Item Name: Crosstube Assembly, Mid Aft

DART AEROSPACE LTD		Work Order: 96766
Description: Crosstube Assembly, Mid Aft		Part Number: D206-667-247TRN
Inspection Dwg: D206-667-247 Rev: A		Page 1 of 2

DRAWING NO. D206-667-247
REV. A
SHEET 1 OF 4

DRAWING NO. D206-667-247	TITLE CROSSTUBE ASS'Y (206L MID AFT)	REV. A	DART AEROSPACE LTD ENGINEERING ORDER		D.E.O. NO. D206-667-247-A-1	SHEET NO. SHEET 1 OF 1	SCALE NTS
DRAWN 97	CHECKED ASS	MFG. APPR. KB	APPROVED JMD		DE APPR. #		
DATE 11.07.15	DATE 11.07.20	DATE 11.07.21	DATE 11/07/21		DATE 11.07.21

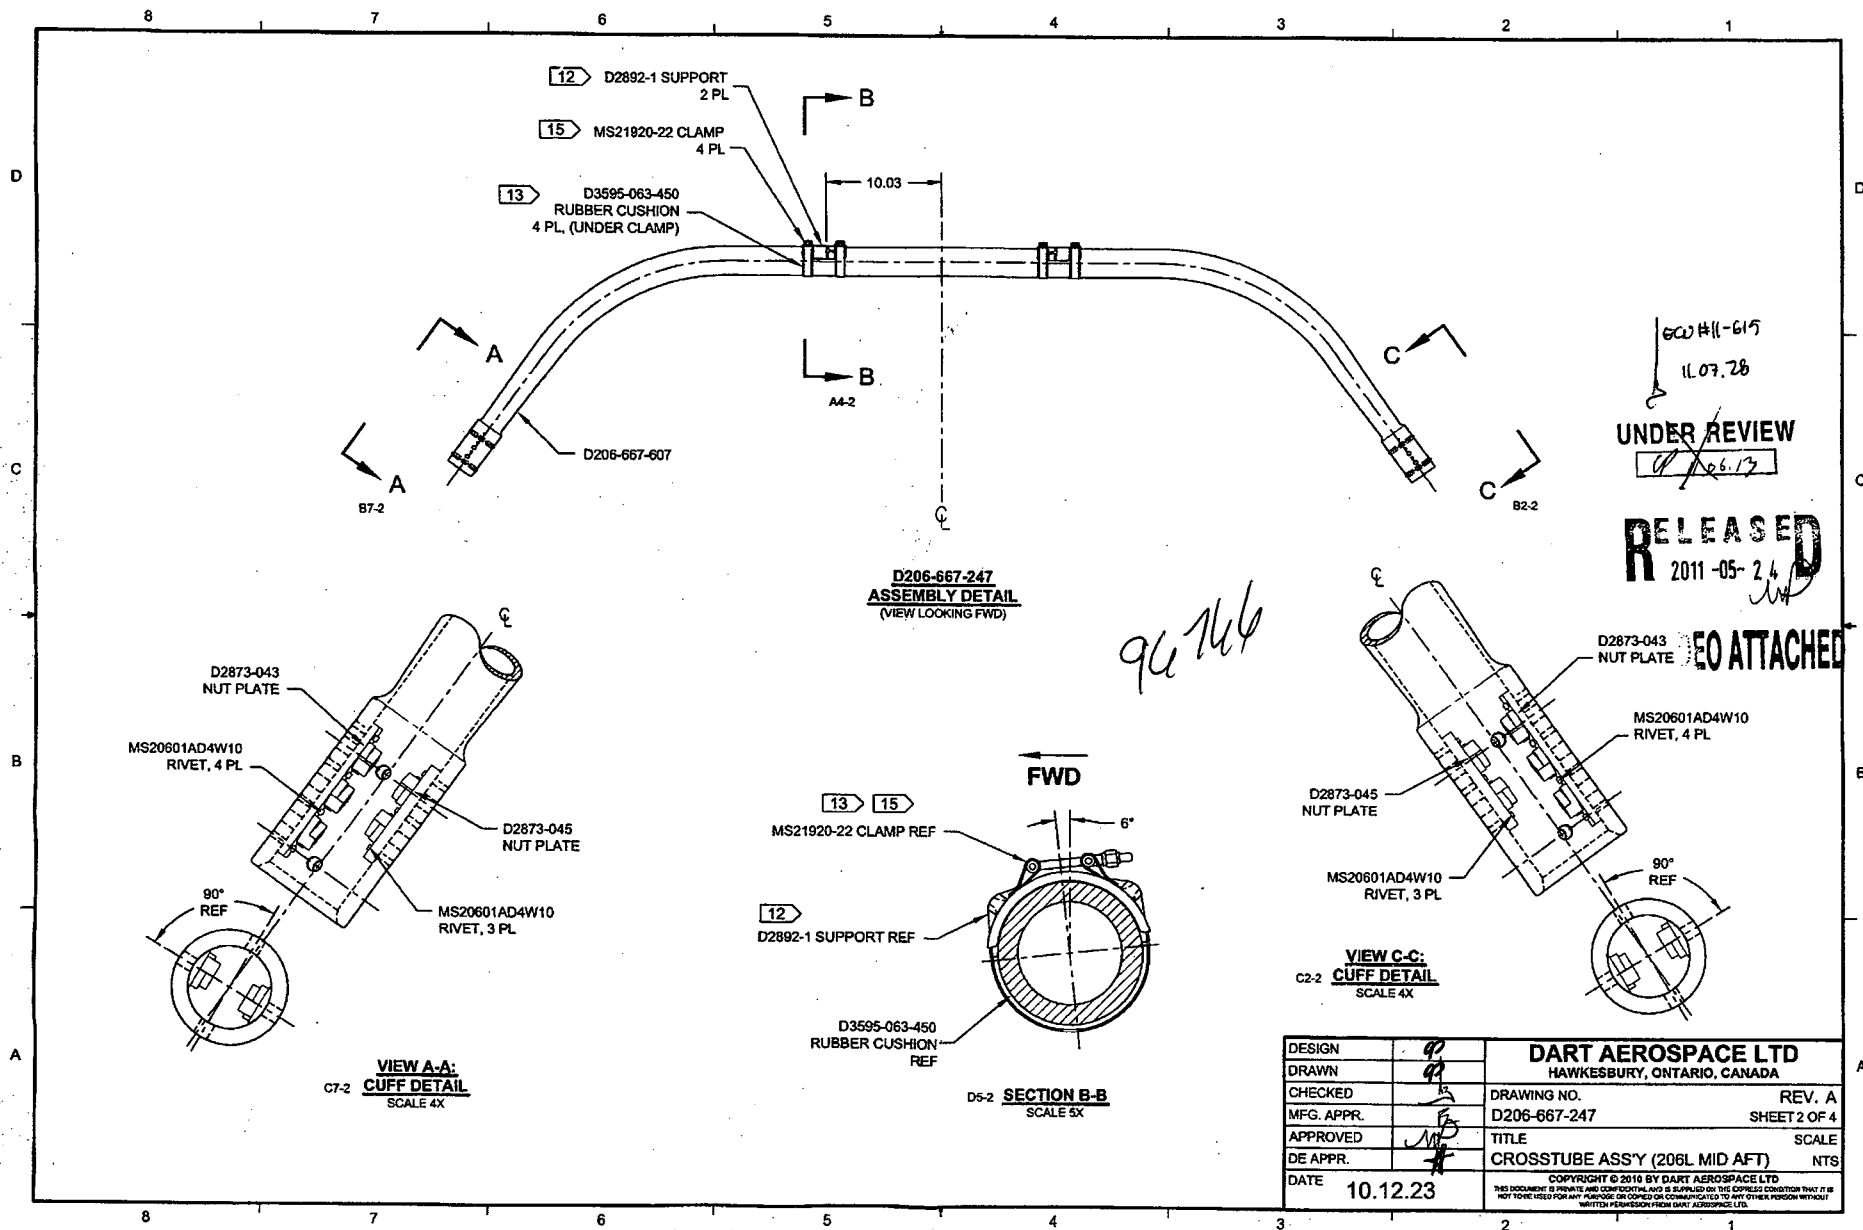
PURPOSE:

REPLACE MAGNOBOND WITH PROSEAL.

Item	Qty -247	Part Number	Description
9	A/R	PROSEAL 890 B-2	SEALANT, AMS-S-8802 CLASS B-2

9	A/R	MAGNOBOND 6398	ROCKWELL SPECIFICATION RBO-120-023 ADHESIVE (TEXTRON/BELL SPEC. 299-947-100, TYPE II, CLASS 2 ADHESIVE)
---	-----	----------------	---

NOTE 12 & 15, SHEET 1 IS AMENDED AS FOLLOWS:

- 12) TO INSTALL D2892-1 SUPPORT: ABRASE MATING SURFACE OF SUPPORT AND CROSSTUBE WITH 180-GRIT SANDPAPER AND REMOVE RESIDUE WITH MEK (OR EQUIVALENT). APPLY A 0.04" TO 0.07" THICK LAYER OF PROSEAL 890 CLASS B-2 (OR AMS-S-8802 CLASS B-2) SEALANT TO MATING SURFACE OF SUPPORT.
- 15) TORQUE CLAMPS 80 TO 100 IN-LB. ENSURE AT LEAST 1.5 THREADS SHOWING IN SAFETY AND THAT NUT HAS NOT BOTTOMED-OUT AFTER TORQUING. **PRIOR TO PACKAGING, RE-CHECK TORQUE ON CLAMPS AFTER PROSEAL 890 SEALANT HAS CURED FOR 72 HOURS.**

- 12) INSTALL D2892-1 SUPPORT USING 0.03" TO 0.06" THICK LAYER OF MAGNOBOND 6398 PER QSI 015. LET CURE FOR 12 HOURS AFTER INSTALLATION AND PRIOR TO PACKAGING.
- 15) TORQUE CLAMPS 80 TO 100 IN-LB. ENSURE AT LEAST 1.5 THREADS SHOWING IN SAFETY AND THAT NUT HAS NOT BOTTOMED-OUT AFTER TORQUING.
